# CITY OF ALBUQUERQUE

RE: **Starbucks Parking lot Changes**  
**8251 Golf Course Rd NW**  
**Grading Plan and Drainage Plan**  
**Engineer's Stamp Date: 7/23/18**  
**Hydrology File: C12D001G4**

## DRAINAGE AND TRANSPORTATION INFORMATION SHEET (REV 6/2018)

RE: **Starbucks Parking lot Changes**  
**8251 Golf Course Rd NW**  
**Grading Plan and Drainage Plan**  
**Engineer's Stamp Date: 2/9/18**  
**Hydrology File: C12D001G4**

ENGINEER'S SEAL	STARBUCKS GOLF COURSE AND PDN GRADING AND DRAINAGE PLAN	DRAWN BY WCWJ
		DATE 2-08-18
		21719-LAYOUT-3-16-17
7/23/18 2/9/18	 <i>Rio Grande Engineering</i> 1606 CENTRAL AVENUE SE SUITE 201 ALBUQUERQUE, NM 87106 (505) 872-0999	SHEET # —
DAVID SOULE P.E. #14522		JOB # 21719

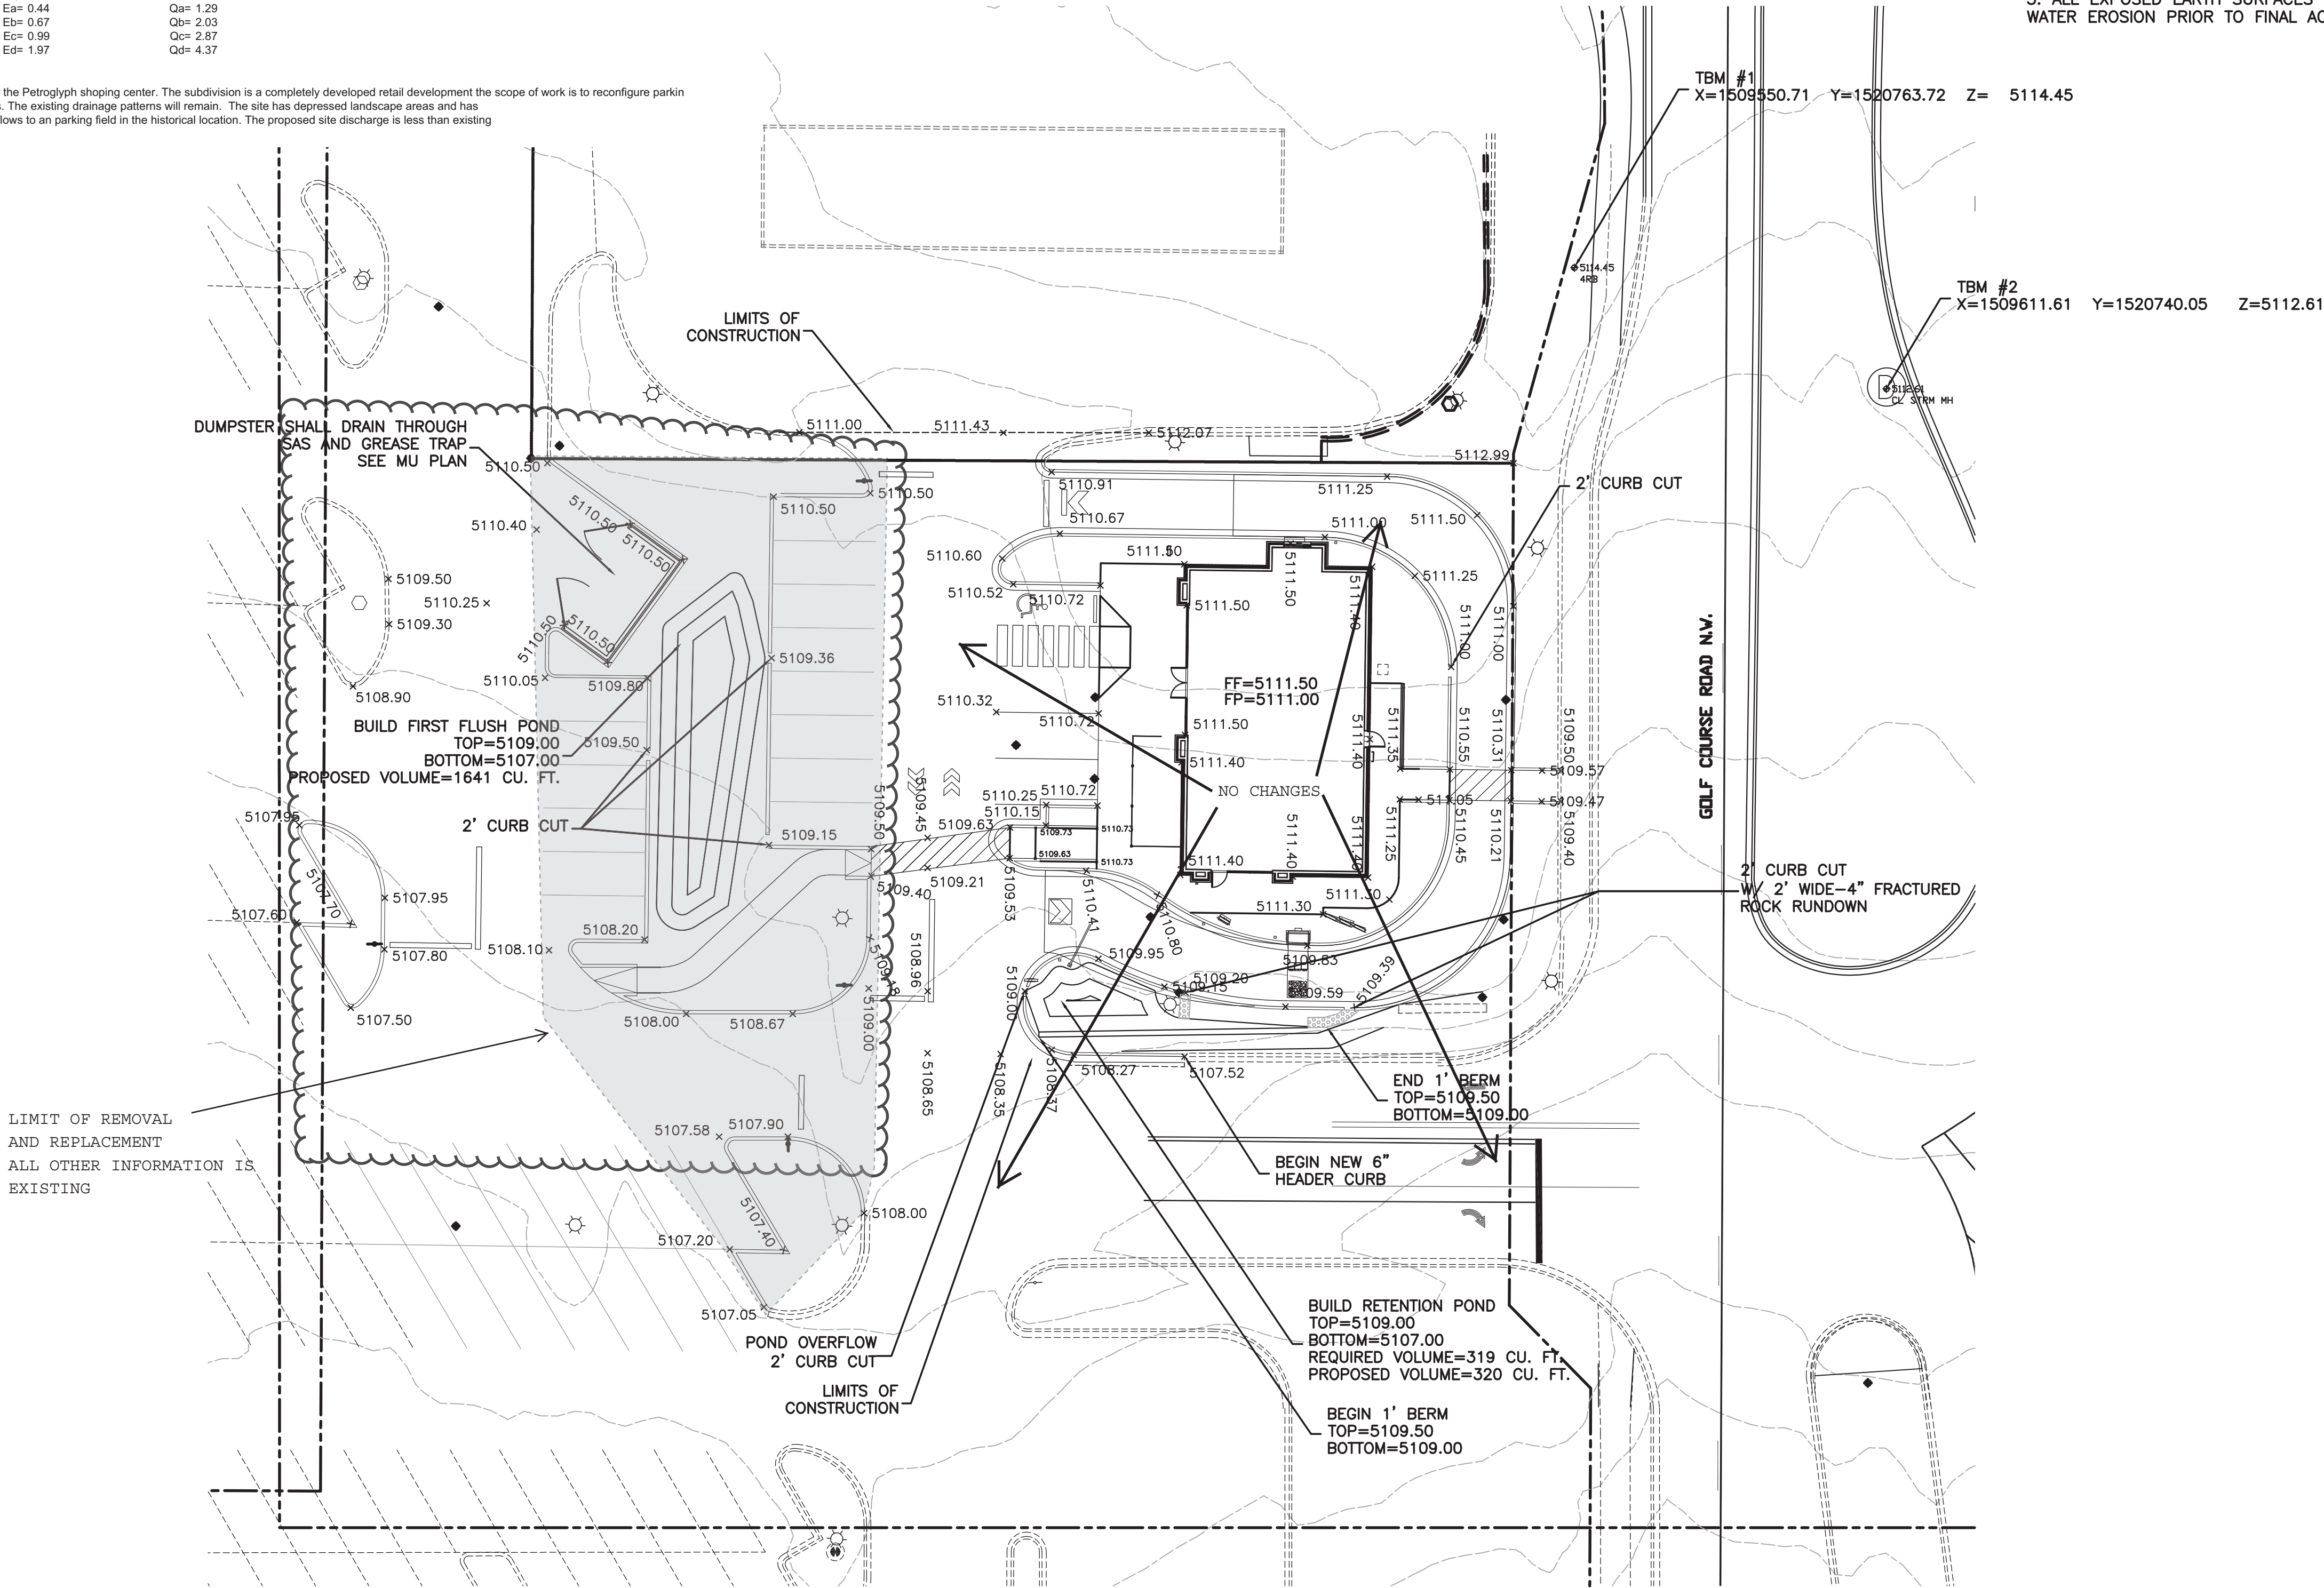
1. A Bernalillo County Recorded [Private Facility Drainage Covenant](#) is required for the first flush pond. The original notarized form, exhibit A (legible on 8.5x11 paper), and recording fee (\$25, payable to Bernalillo County) must be turned into DRC (4th, Plaza del Sol) for routing. Please contact Charlotte LaBadie (clabadie@cabq.gov, 924-3996) or Madeline Carruthers (mtafoya@cabq.gov, 924-3997) regarding the routing and recording process for covenants.

1. Provide a drainage narrative or Drainage Report, describing the existing and proposed conditions, including runoff rates, flowpaths, grades, and proposed improvements.

2. The site must demonstrate adequate downstream capacity per § 14-5-2-12(G) of the Albuquerque Code of Ordinances.
3. Clearly define the limits of grading and limits of paving, and provide their areas; the newly constructed Starbucks should be shown as existing and not part of this parking lot change.

4. Provide adequately sized first flush retention ponding, sized for the 80<sup>th</sup> percentile storm (redevelopment project) and demonstrate that the first flush runoff is captured by the proposed pond.

5. A Bernalillo County Recorded [Private Facility Drainage Covenant](#) is required for the first flush pond. The original notarized form, exhibit A (legible on 8.5x11 paper), and recording fee (\$25, payable to Bernalillo County) must be turned into DRC (4th, Plaza del Sol) for routing. Please contact Charlotte LaBadie (clabadie@cabq.gov, 924-3996) or Madeline Carruthers (mtafoya@cabq.gov, 924-3997) regarding the routing and recording process for covenants.
